Application for Works Approval Amendment

Works Approval Number W6875/2023/1

Premises Project Ceres

Date of Report 20 February 2026

Figure 1: Predicted noise levels (HAS 2025).

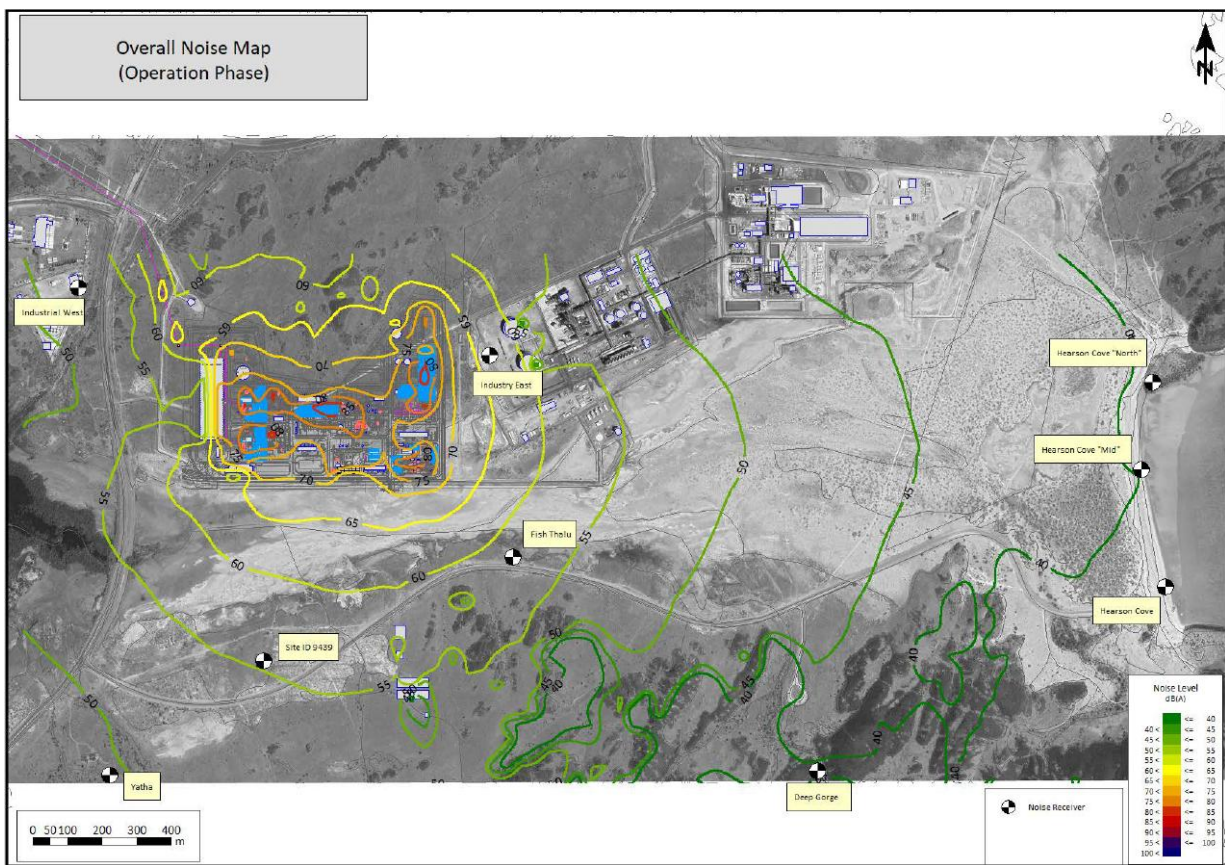
Consistent with initial modelling, the results indicate that noise levels received at sensitive receptors such as Deep Gorge (Nganjarli) and Hearson Cove remain well below the assigned noise level of 65dB(A) (Figure 1), and therefore risk of impact to these locations remains low. Noise levels at the identified heritage sites were also assessed and found to be below the assigned level.

Although the updated modelling continues to predict a technical exceedance of the assigned noise level at certain boundary locations, the risk remains low due to the absence of receptors in those areas. It is important to recognise that noise modelling is a predictive tool, intended to estimate potential noise impacts. The delegated officer notes that the modelling adopts a conservative approach, assuming worst-case conditions; specifically, that all equipment operates simultaneously and that meteorological conditions favour maximum noise propagation. In practice, such a scenario may not occur due to variations in operating conditions. For instance, the use of the flare typically does not coincide with full plant load, meaning not all noise sources are active at the same time. This inherent conservatism in the modelling further supports the possibility that the actual risk of exceedance is low.

Given this context, and the low risk associated with the predicted technical exceedances, the delegated officer considers the most appropriate and practical response is to require the Works Approval Holder to undertake noise monitoring during commissioning and time limited operations. This will serve to validate the model predictions and determine whether further noise reduction is necessary to achieve the assigned noise levels at the boundary of the premises. If monitoring demonstrates that assigned noise levels are not being achieved, the works approval holder will be required to implement additional control measures.

Figure 2: Wastewater schematic showing monitoring point locations.

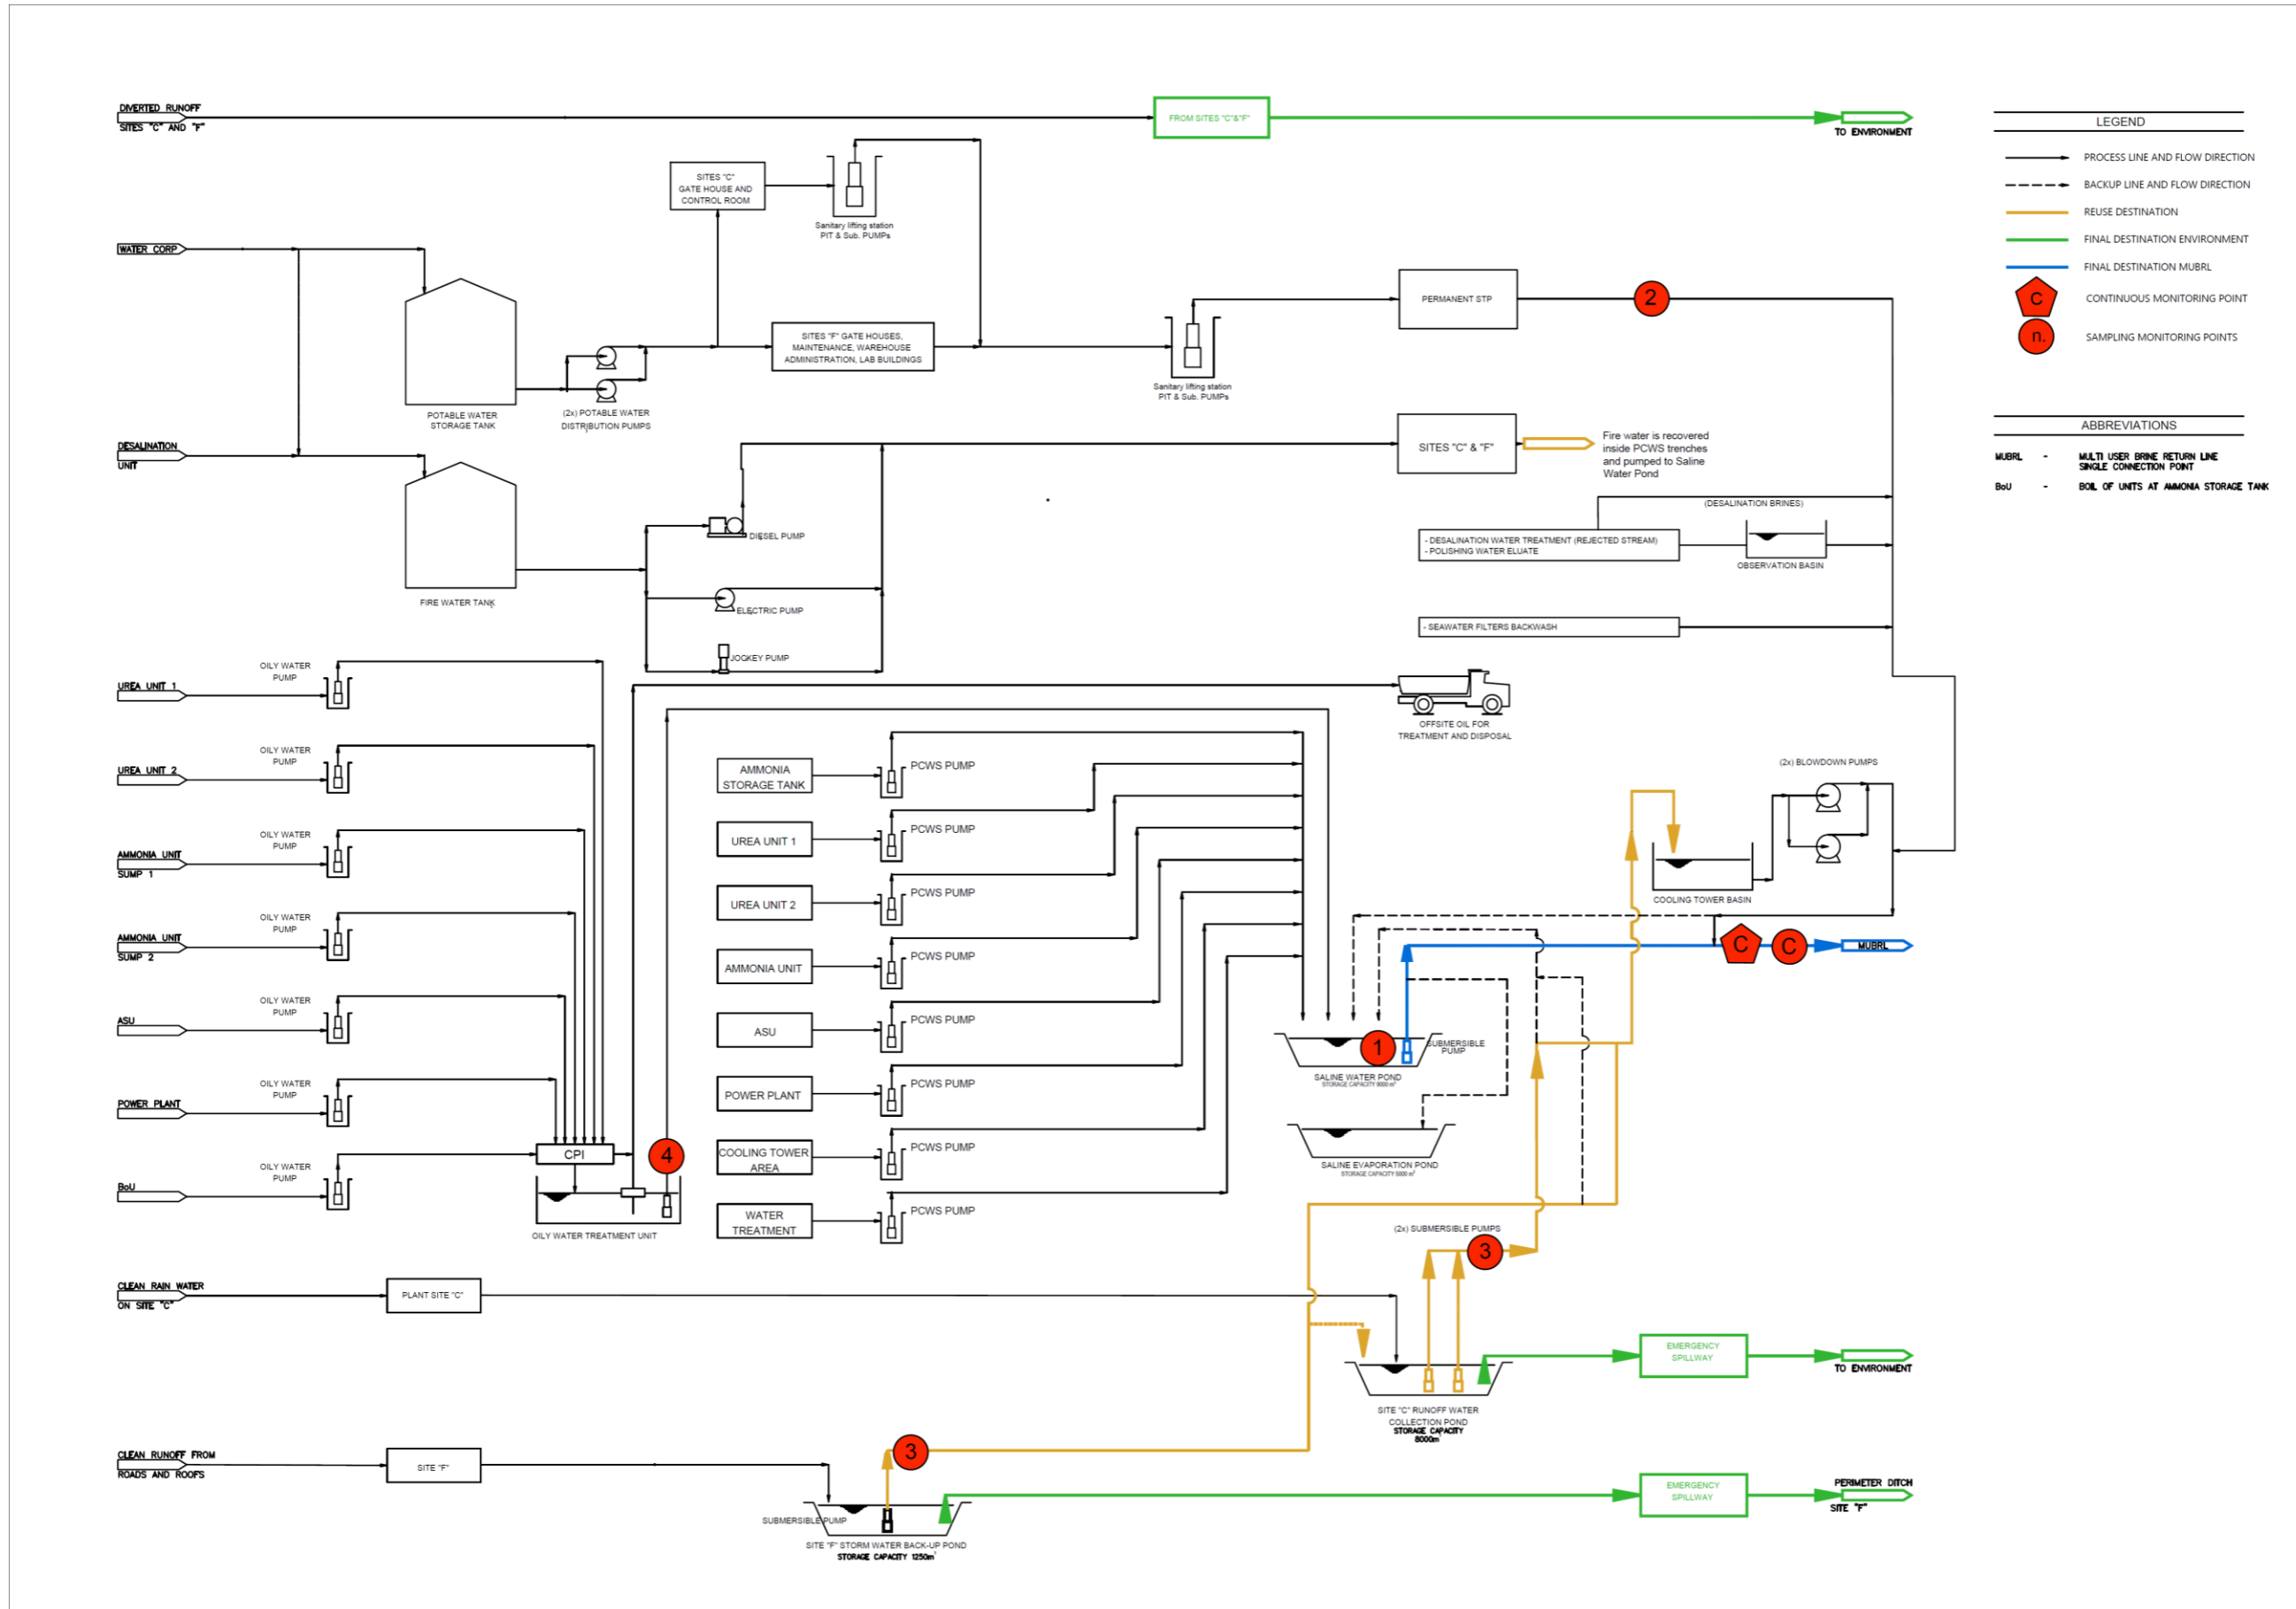
To provide greater assurance that the waste stream is meeting discharge criteria, particularly during commissioning, the delegated officer considers that sampling should occur more frequently (e.g. 5-7 days per week), with samples composited into a weekly sampled. Use of the monthly rolling average based on these weekly composite samples is considered suitable. This approach is expected to better capture potential short-term variability in water quality and provide greater certainty that discharges limits are consistently achieved.

occur on a six-monthly basis, however, the delegated officer considers that external analysis should occur at a higher frequency (i.e. monthly) during commissioning to ensure reliability of data, especially during initial operations when laboratory processes are being established. Monthly samples, collected separately from those used for the weekly composite analysis, must include replicates and duplicates subject to both internal and external laboratory analysis. This verification process will provide greater confidence in the accuracy of the onsite laboratory results. Discharge from the Clean Water Ponds at Sites C and F to the supratidal flats has not been conditioned on the works approval noting that these discharges are managed under Part IV of the EP Act via the Surface Water Management Plan developed under MS 1180.
